Historic Architectural Review Commission
Staff Report for Item 4

Applicant: Artibus Design

Address: #719 Fleming Street

Description of Work:
Demolition of non-historic accessory structure.

719 Fleming St, Pool House

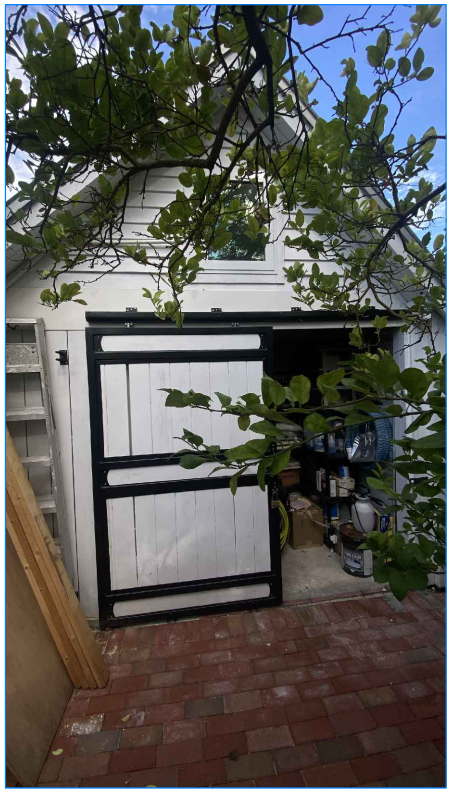
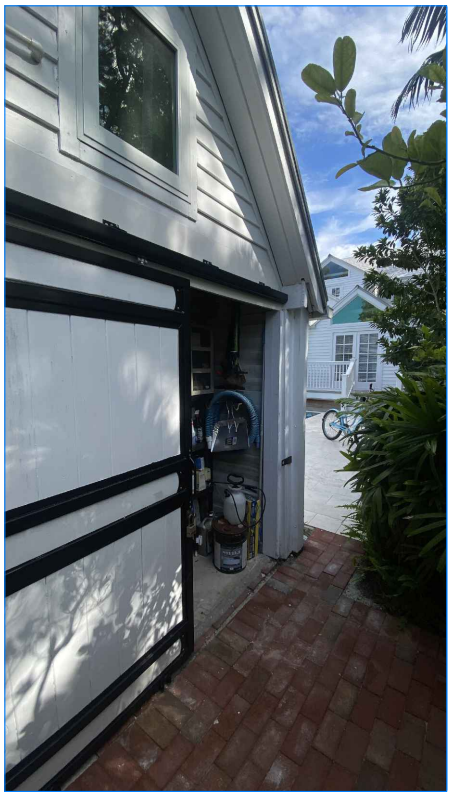
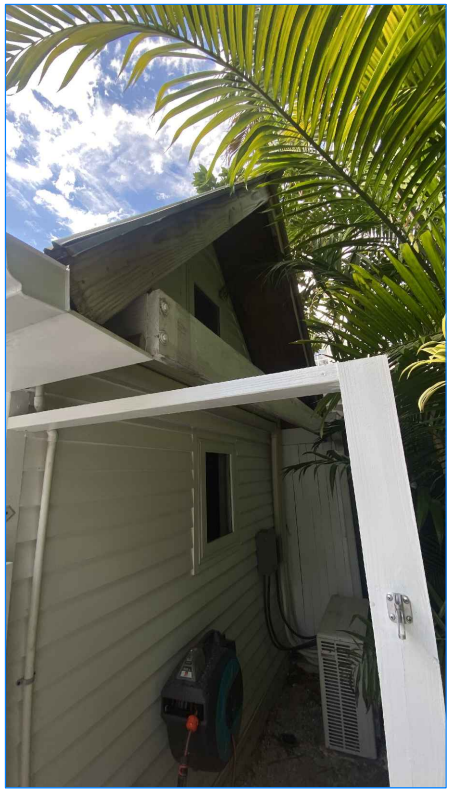
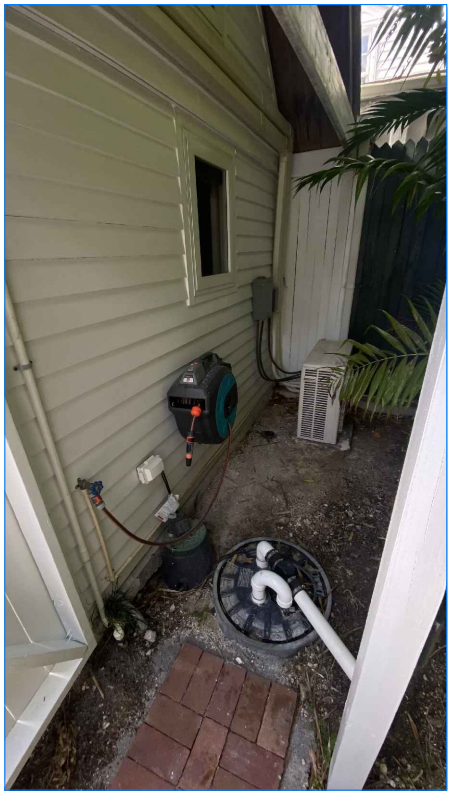
Site Facts:
The property under review contains a historic two-and-a-half-story frame vernacular principal structure and a non-historic one-story accessory structure. The principal structure is listed on our survey as contributing, with a year built circa 1886. The existing accessory structure was built without permits in 2020 and sits directly on the rear property line of 719 Fleming.

It is staff's opinion that the removal of the non-historic accessory structure will not have a negative effect on the character of the surrounding neighborhood.

The accessory structure is non-historic.

The accessory structure under review has not acquired historic significance that is important to the site or surrounding district.

It is staff's opinion that the accessory structure in question will not qualify as a contributing element to the site or to the historic district in the near future.

It is staff's opinion that the Commission can review the request for demolition. If approved, this will be the only required reading for demolition.

EXISTING SITE PLAN / DEMO

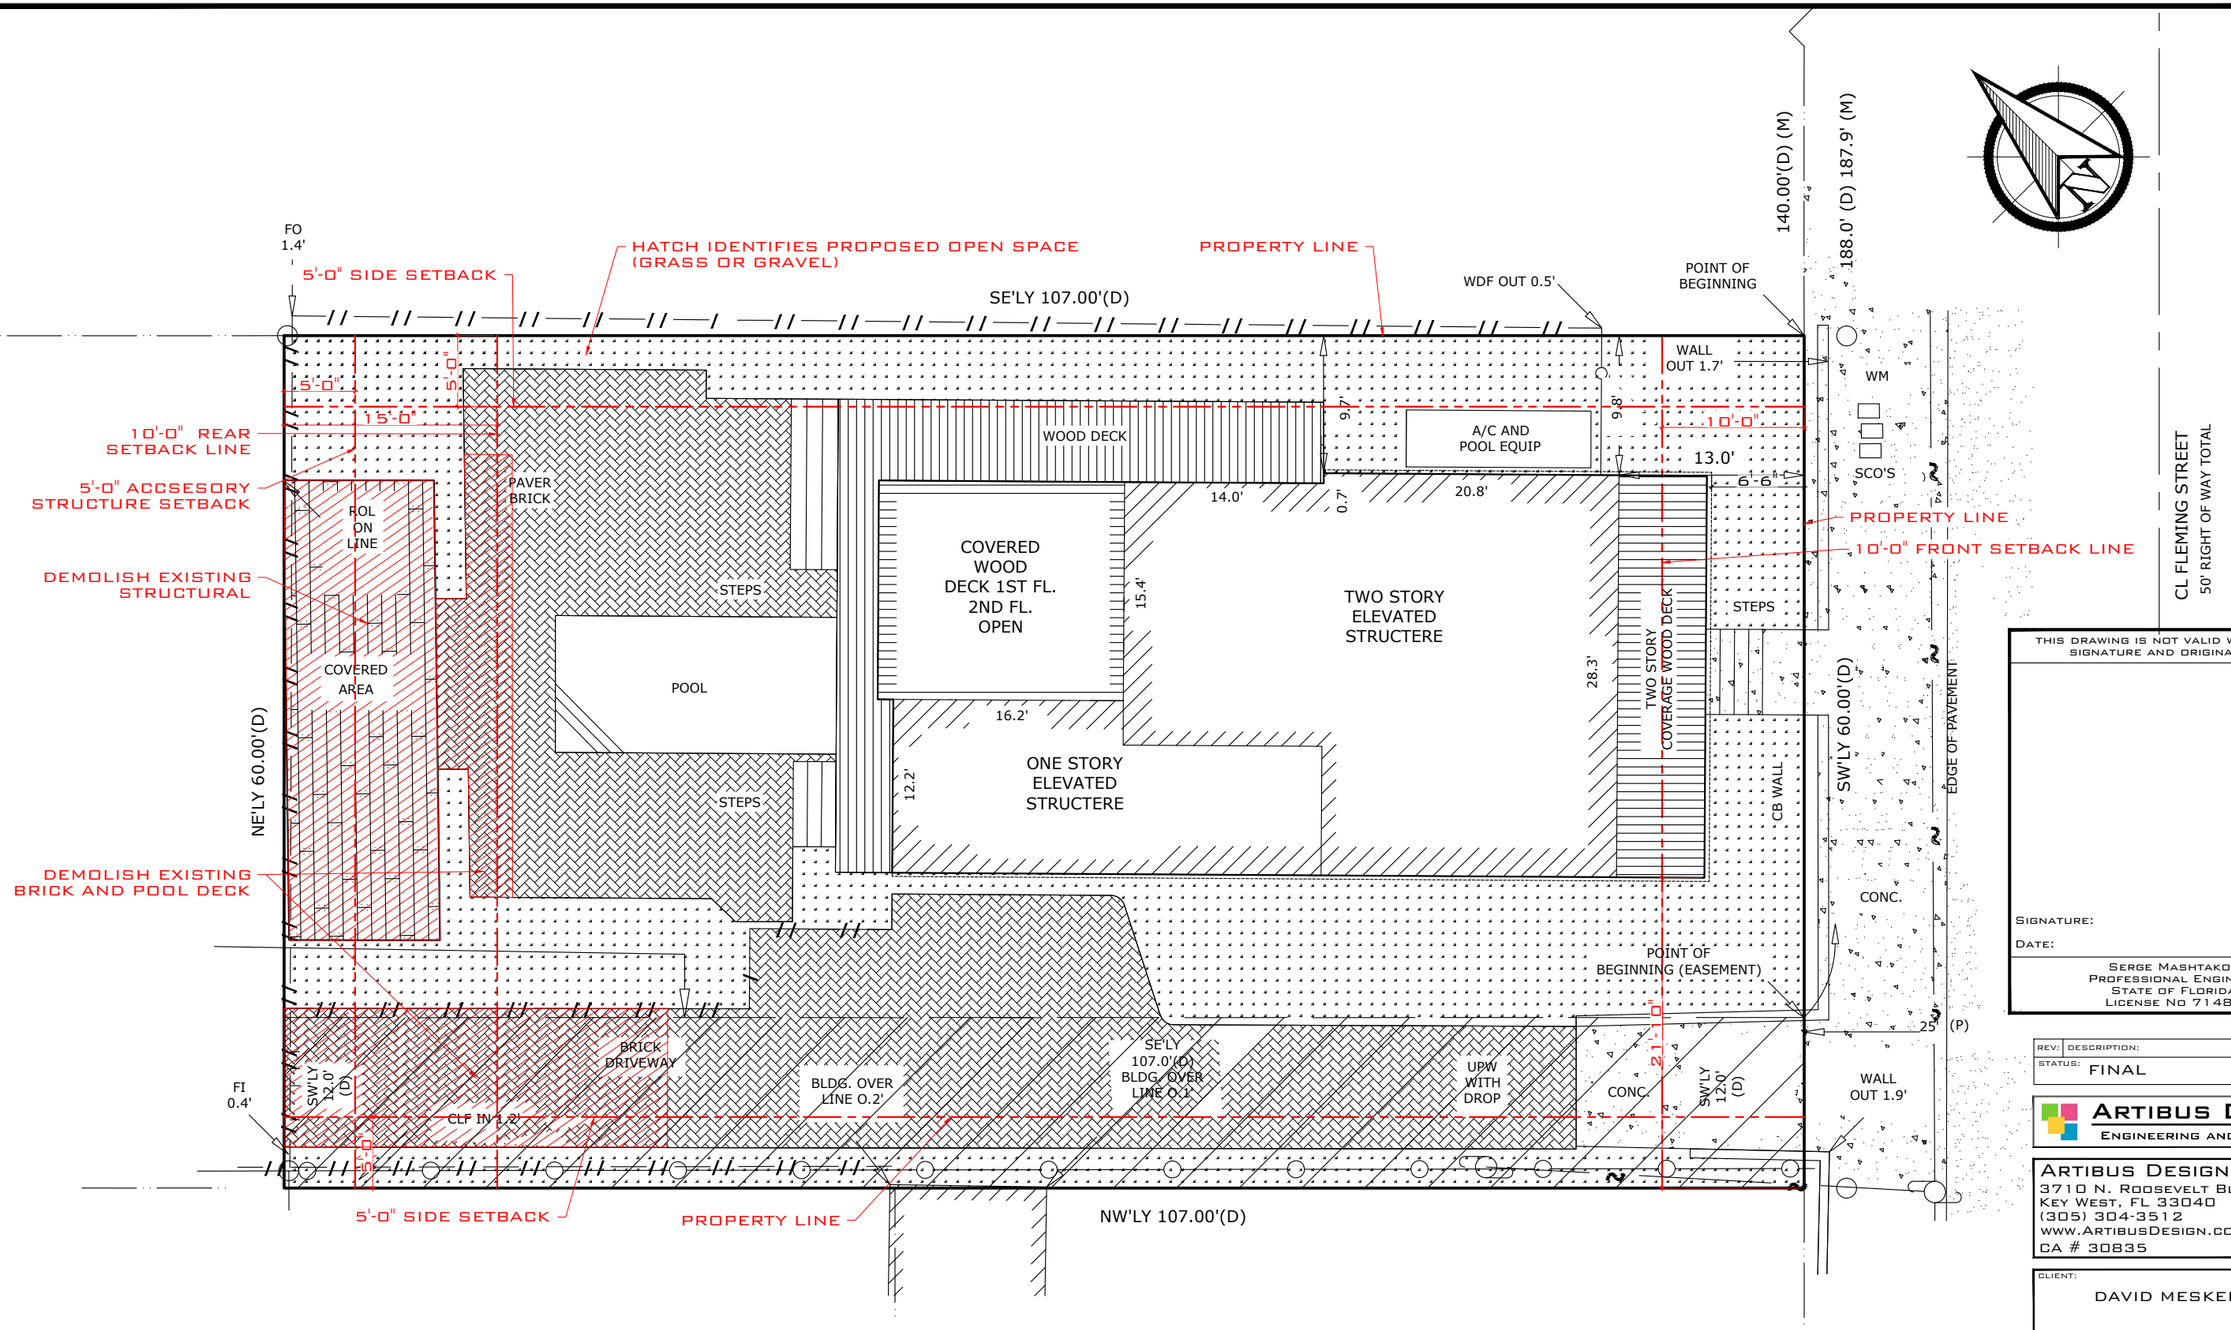
Staff Analysis:
The Certificate of Appropriateness under review proposes the demolition of a non-historic accessory structure at the rear of the property. The proposed demolition would allow for the construction of a new one-story accessory structure that meets the required setbacks. Plans for the new accessory structure are under review as part of this application.
